Submission of Further Information (FI)

**Proposed Temporary Warehouse (excluding Dangerous Goods Godown)
With Ancillary Office and Associated Filling of Land for a Period of 3 Years in
“Agriculture” Zone, Lots 1012 S.B, 1012 S.C, 1013, 1014 RP, 1015 S.A, 1015 S.B,
1015 RP, 1016 (Part), 1018, 1034 (Part) and 1035 in D.D.113,
Kam Tin, Yuen Long, New Territories
(Application No. A/YL-KTS/1125)**

Further Information for Planning Application No. A/YL-KTS/1125**Response-to-Comments****Comments from Environmental Protection Department**

**Plan 3a
(P 25012)**

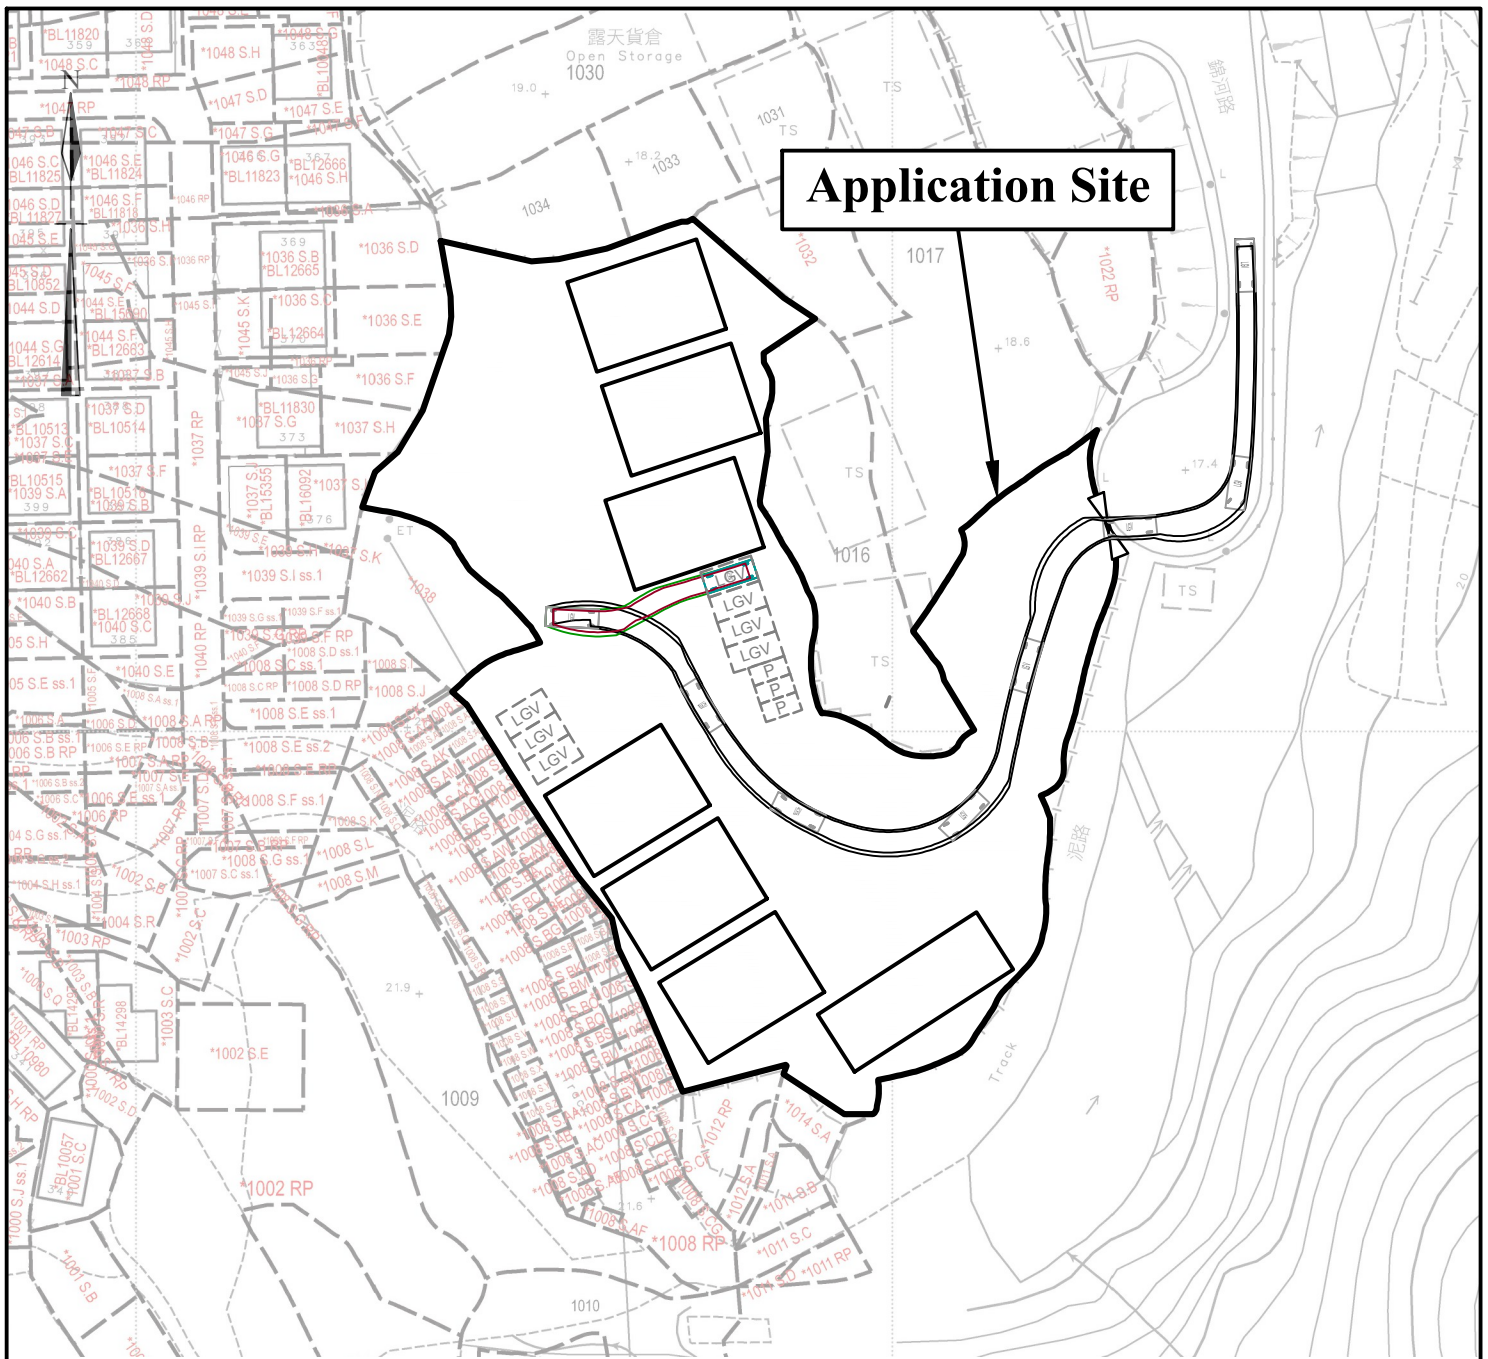
We would also like to clarify that light goods vehicles are proposed to be used for the daily operation of the proposed development. The average trip attraction and generation rates are relatively low (total trips of 7 attractions and 7 generations per day as mentioned in the Planning Statement). It would not disrupt/affect the daily life of the local residents. The operation hours are restricted from 9 a.m. to 7 p.m. daily from Mondays to Saturdays. Beyond operation hours, no vehicle travel to/from the site will be allowed. Drivers will be reminded to pay more attention to the pedestrians on the road. As such, the proposed development should not cause adverse traffic impacts to the adjacent areas and road network.

In view of the amendment made, we enclose the revised pages of the application form, planning statement (Appendix I), Layout Plan (Plan 3a) and Swept Path Analysis (Plan 4a) for your consideration.
